Review of Available Water Temperature Data and Thermal Plume Characterizations related to the Merrimack Power Station in Bow, NH

December 11, 2017

1.0 Introduction

Figure 11. Daily Water Temperature Measurements at Three Monitoring Stations Compared to Selected Fish Tolerance Temperature Thresholds – August 2010

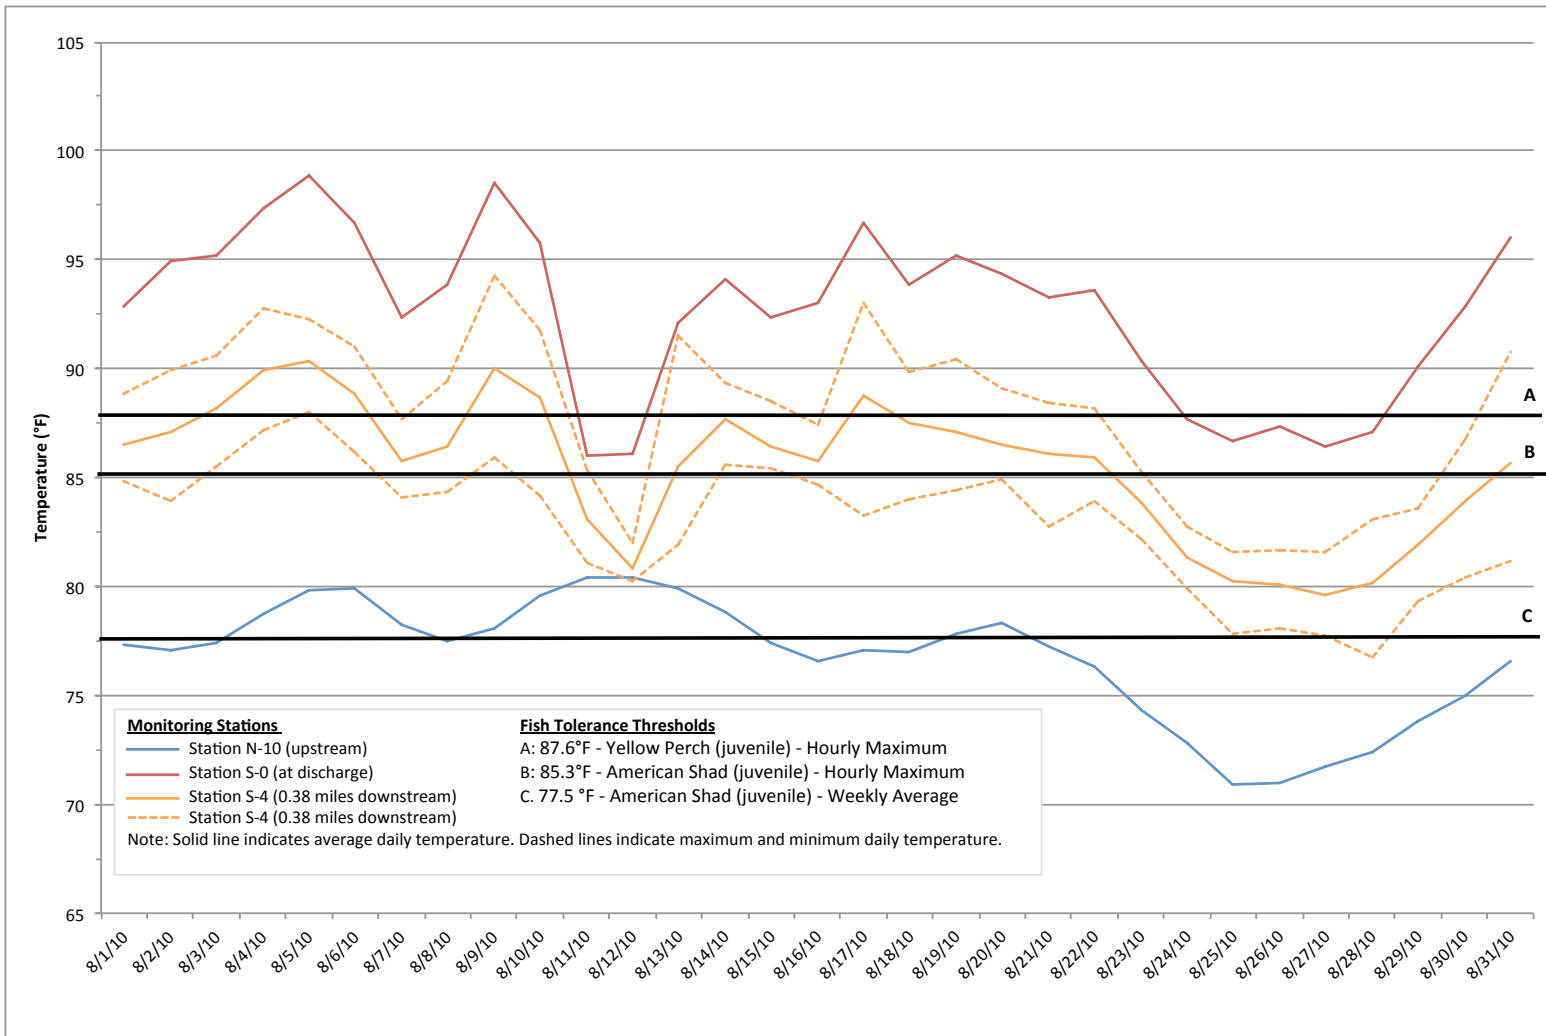
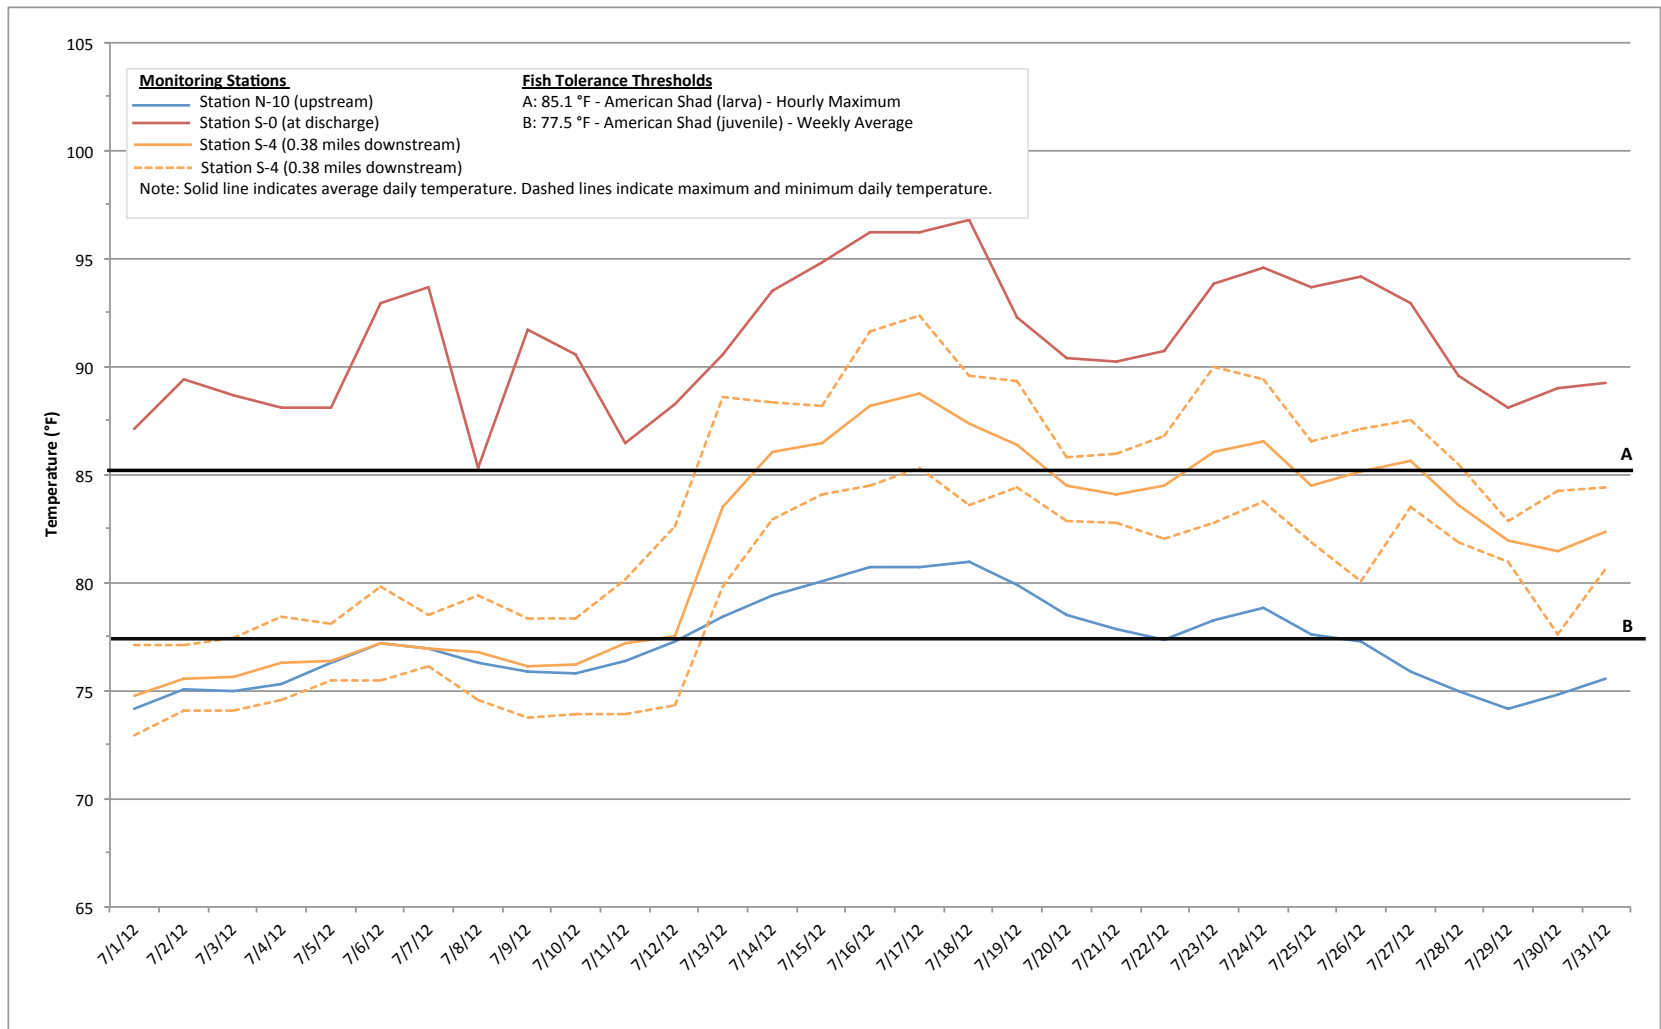
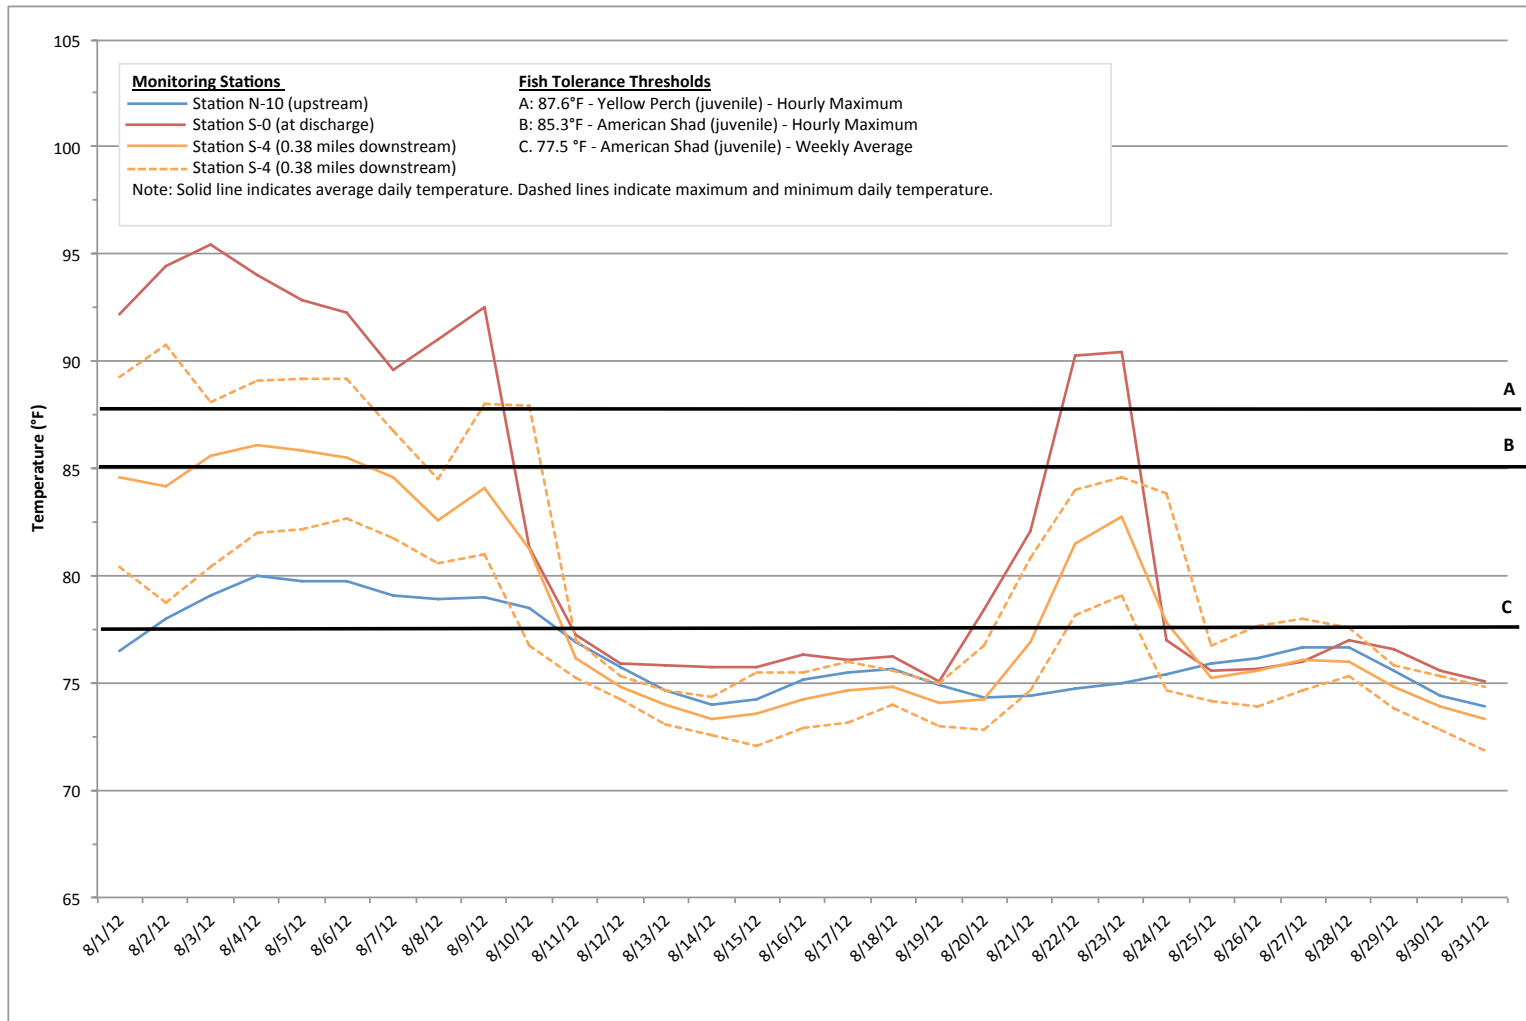
Water temperature measurements and selected applicable fish tolerance thresholds are presented for July and August of 2005, 2007, 2010, and 2012 in Figures 6 through 13. These figures show exceedances of acute and average weekly fish tolerances for extended time periods at Merrimack River stations.
